Sheet #7913

## BORGESON POWER-STEERING UNIT MOUNTING HOLES MODIFICATION

67-76 A-body applications only

Pic1: Modified mounting holes

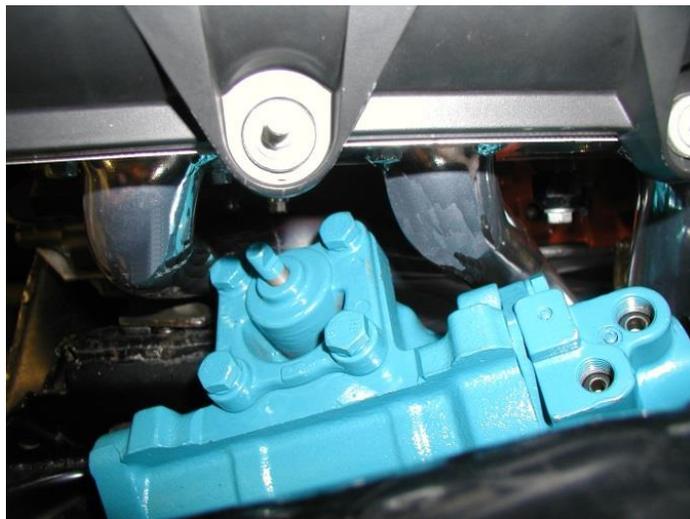
Applies to 67-76 A-body applications only: DIY modification required to the units mounting holes. The three mounting holes must be elongated to  $.810''$  to allow the steering unit to be moved away from the engine for adequate clearance from the header tubes.
